Addendum Number One

Vallecitos Kitchen Door

October 28, 2024

Architect's Project Number: VSVES06

ACCESSIBLE SINK

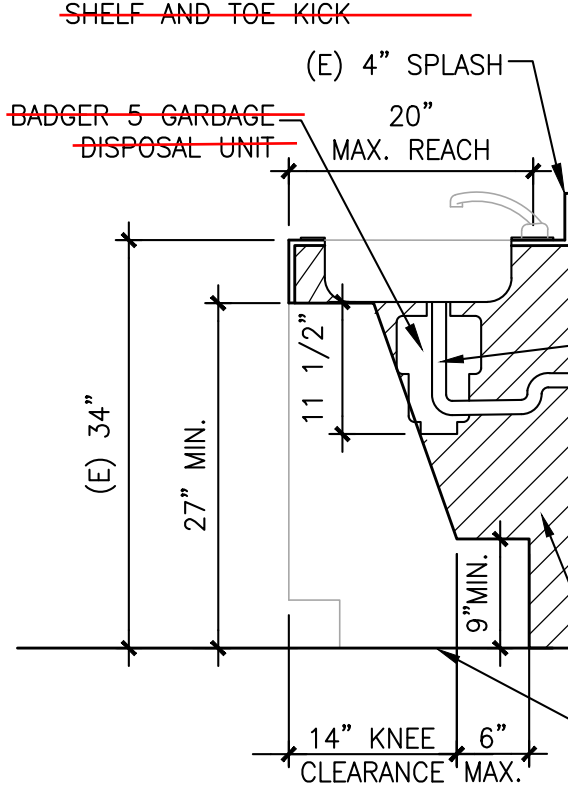
1. **New Kitchen Door is to be hollow-metal, with knock-down frame.**
2. Please clarify the sink and faucet; make and model.
 1. Cabinet sink detail to be used for ADA Clearances and depth. See revised detail attached.

~~WHERE BASE CABINET DOORS
ARE SHOWN. OMIT BASE
SHELF AND TOE KICK~~

AREA NOT HATCHED BELOW COUNTER MUST BE ACCESSIBLE AND CLEAR.

VERIFY IN FIELD THAT THE GARBAGE DISPOSAL UNIT AND ANY ASSOCIATED PLUMBING DOES NOT ENCRANCH UPON THE ACCESSIBLE AREA BENEATH THE COUNTER, AS ILLUSTRATED. IF ENCRANCHMENT OCCURS, RE-INSTALL THE GARBAGE DISPOSAL UNIT ACCORDINGLY
